# Addendum 04

**PROJECT:** Fort Loramie Local Schools Athletic Complex Building & Associated Improvements  
600 East Park Street  
Fort Loramie, Ohio 45845

**PROJECT #:** 25041.00

SHEET NUMBER:  
**A7.1**

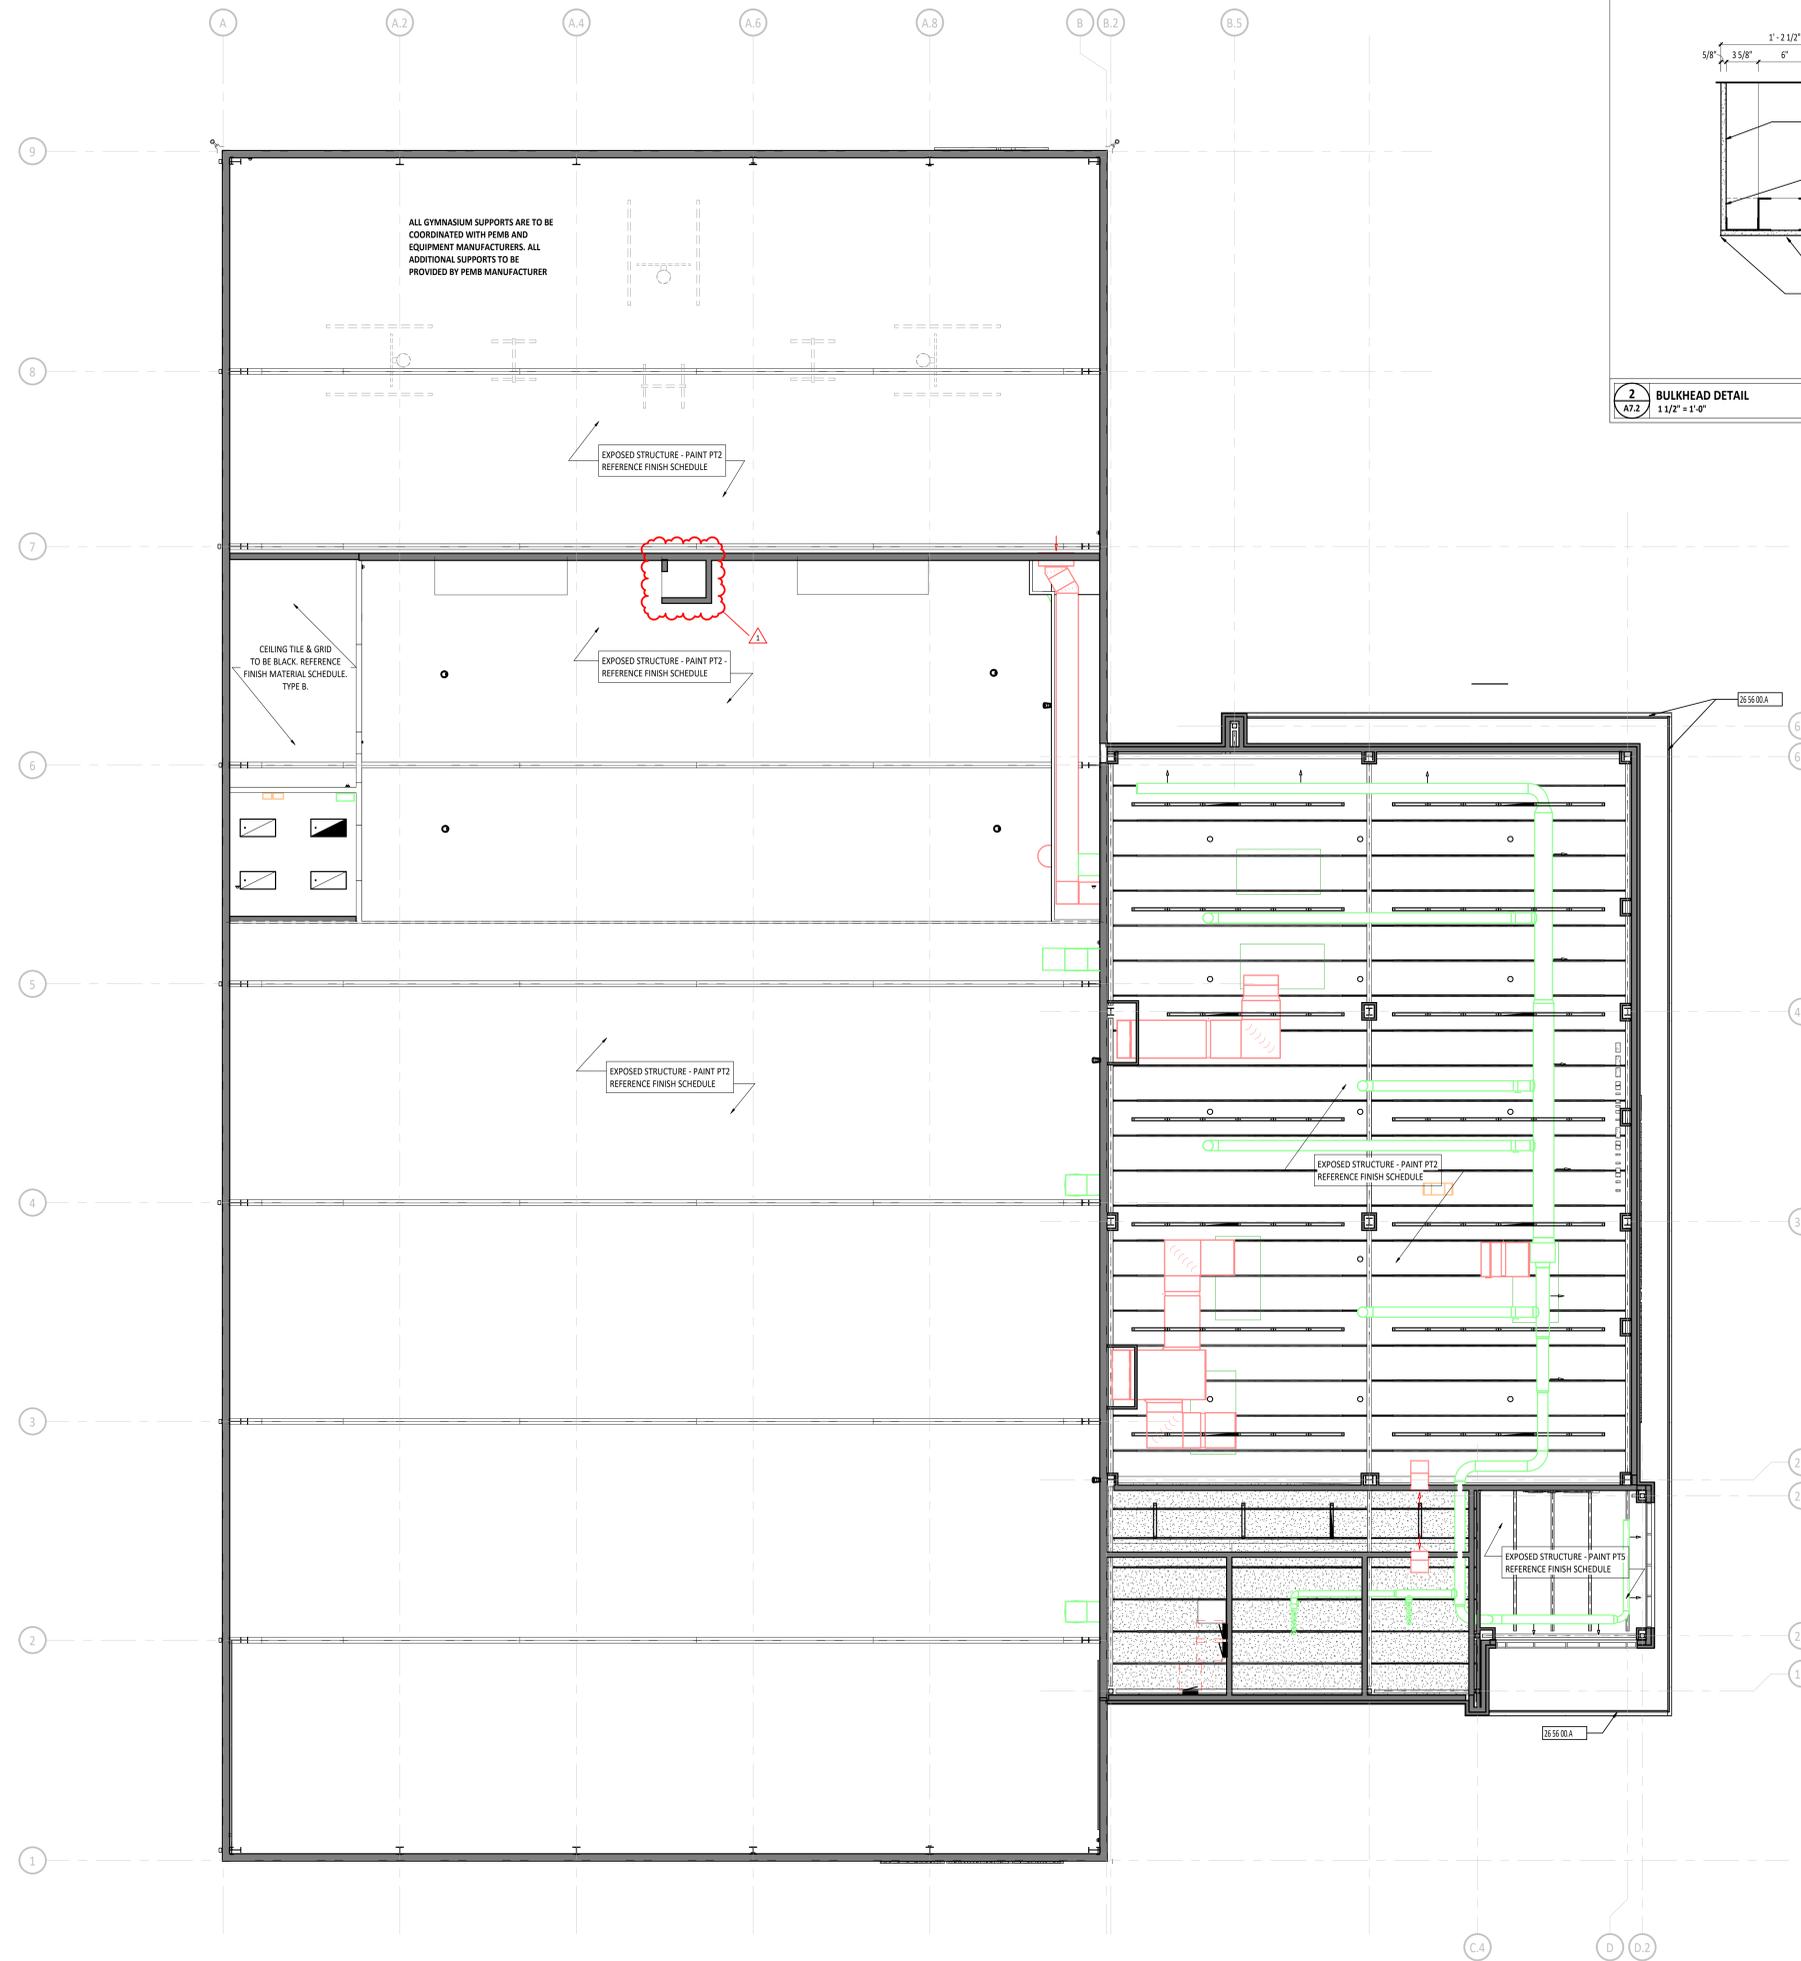
- a. Add Recessed Pit Wheelchair lift
  - b. Modify masonry walls to accommodate shaft
7. Sheet 7.2 – Mezzanine Floor Reflected Ceiling Plan
  - a. Add Recessed Pit Wheelchair Lift

SHEET NUMBER:  
**A8.1**

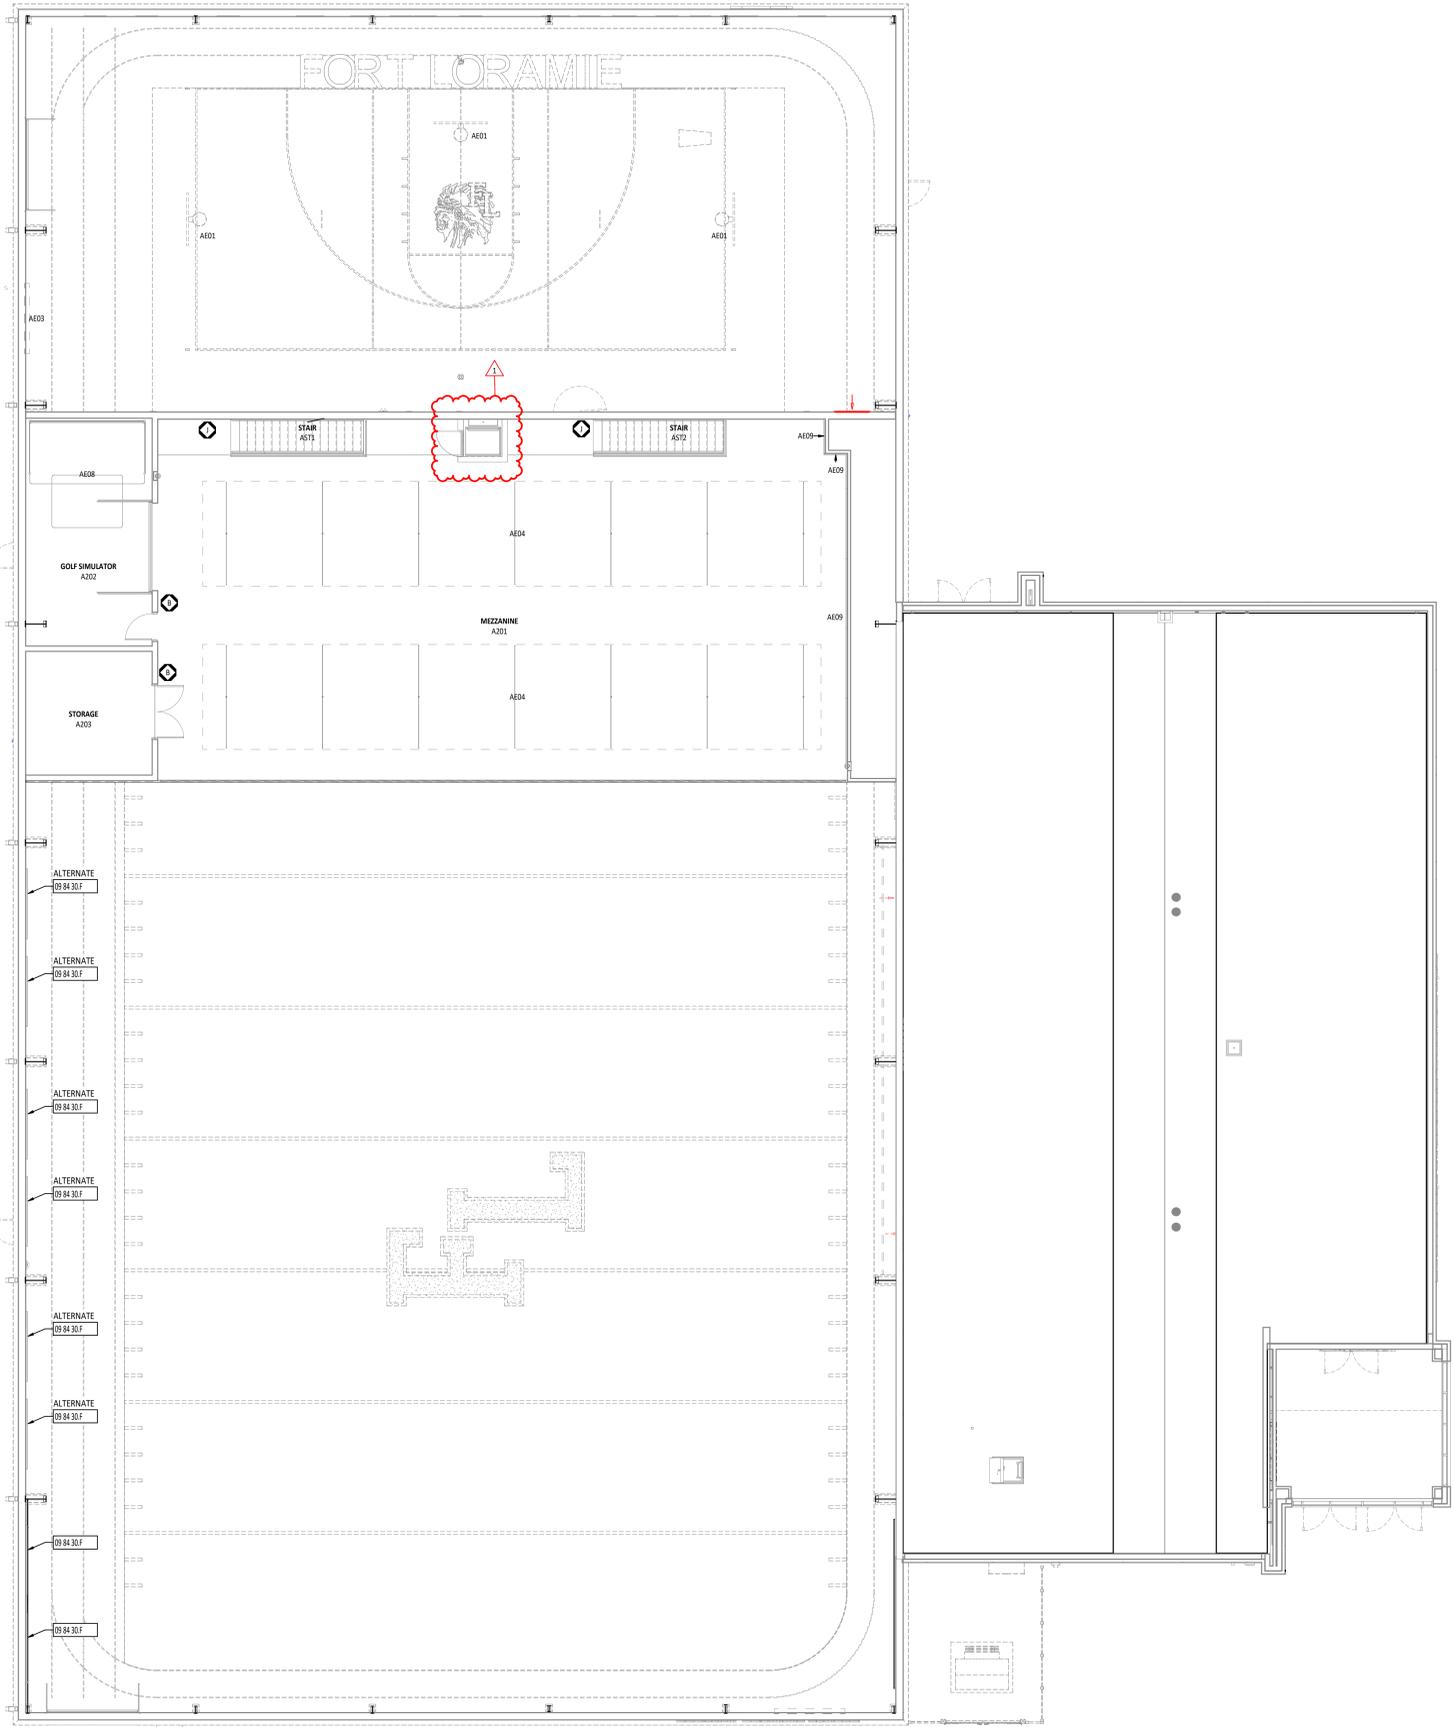
8. Sheet A8.1 – First Floor Equipment Plan
  - a. Add Recessed Pit Wheelchair lift
9. Sheet A8.2 – Mezzanine Equipment Plan
  - a. Add Recessed Pit Wheelchair Lift

SHEET NUMBER:  
**A9.1**

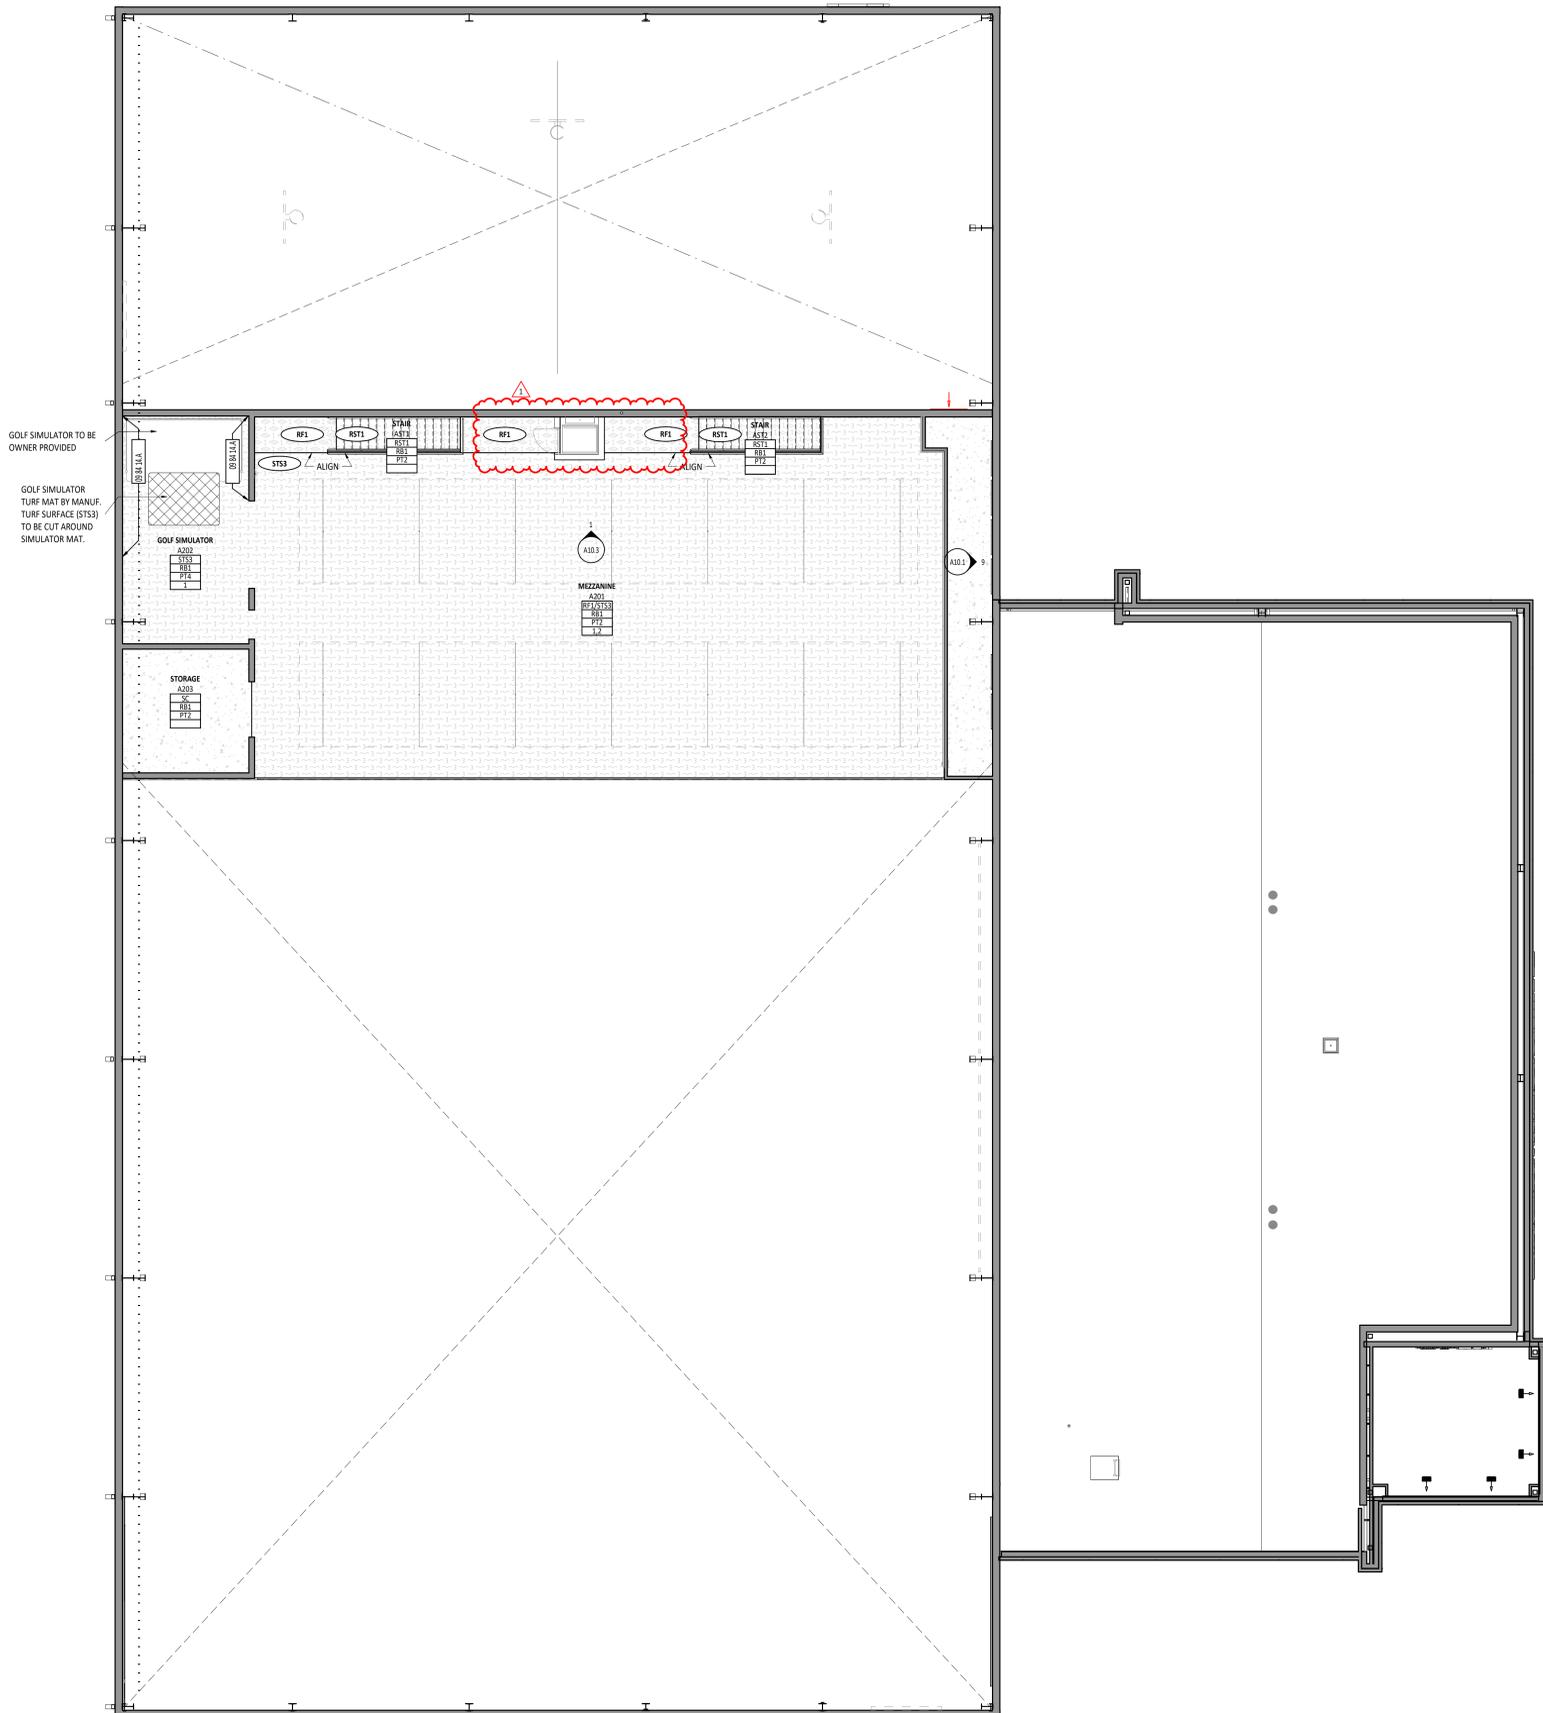
10. Sheet A9.1 – First Floor Finishes Plan
  - a. Add Recessed Pit Wheelchair lift
11. Sheet A9.2 – Mezzanine Floor Finish Plan
  - a. Add Recessed Pit Wheelchair Lift

SHEET NUMBER:  
**S1.1**

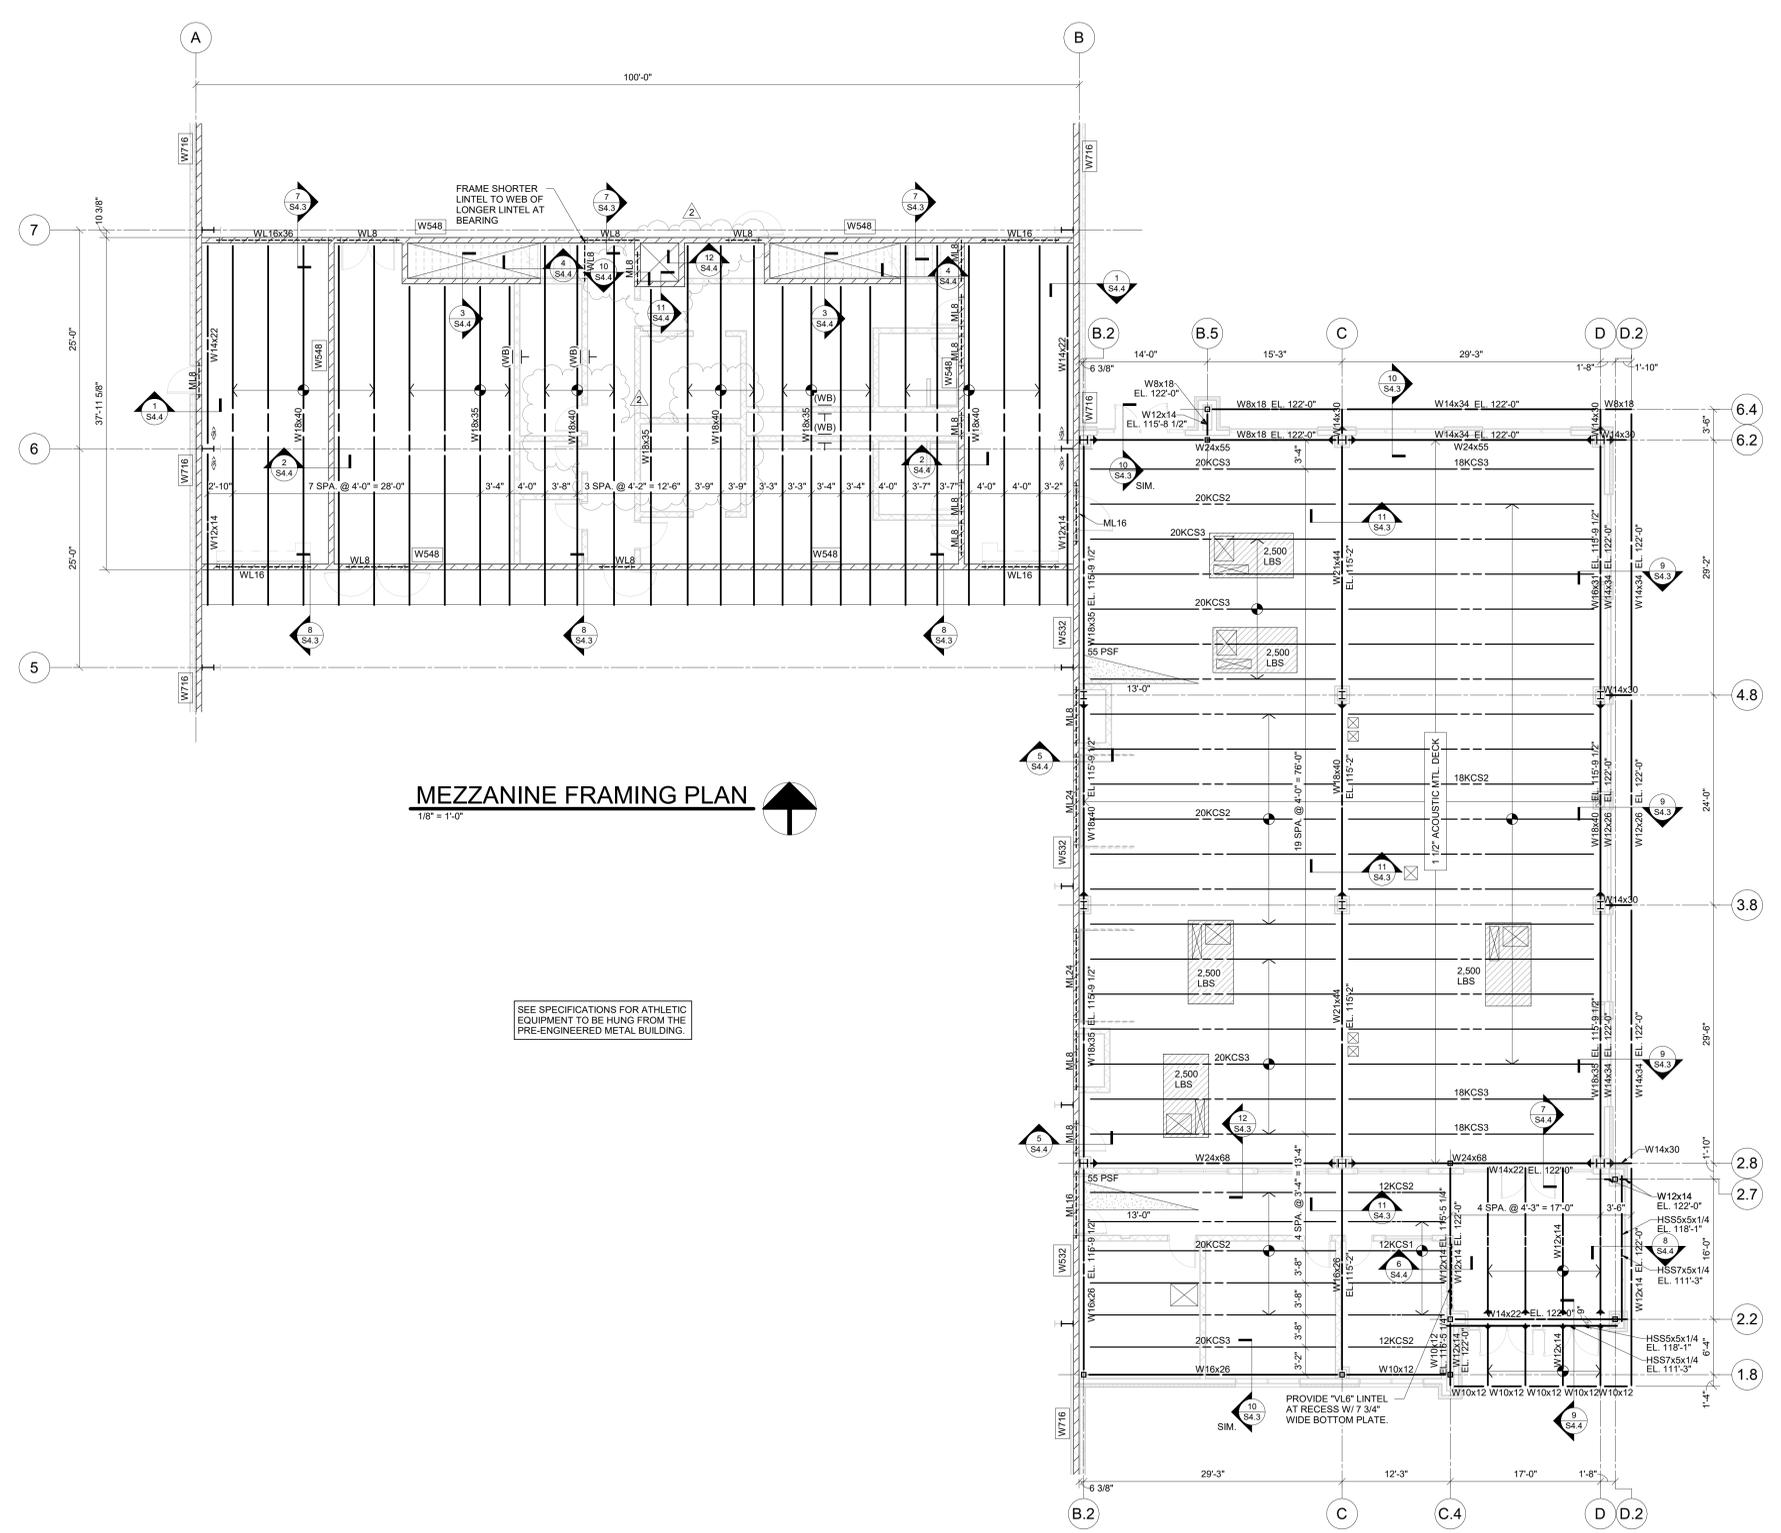
12. Sheet A9.3 – Enlarged Floor Pattern plan RR1/RR2/RR3
  - a. Revised verbiage to say “Water Jetted Graphic Logo” on the weightroom rubber flooring.
13. Sheet S1.1 – Foundation Plan

- a. Added foundation walls and recessed slab at new Lift A122.
14. Sheet S3.1 – Framing Plan
  - a. Added walls and details around new Lift A122.
  - b. Adjusted Framing due to new lift A122
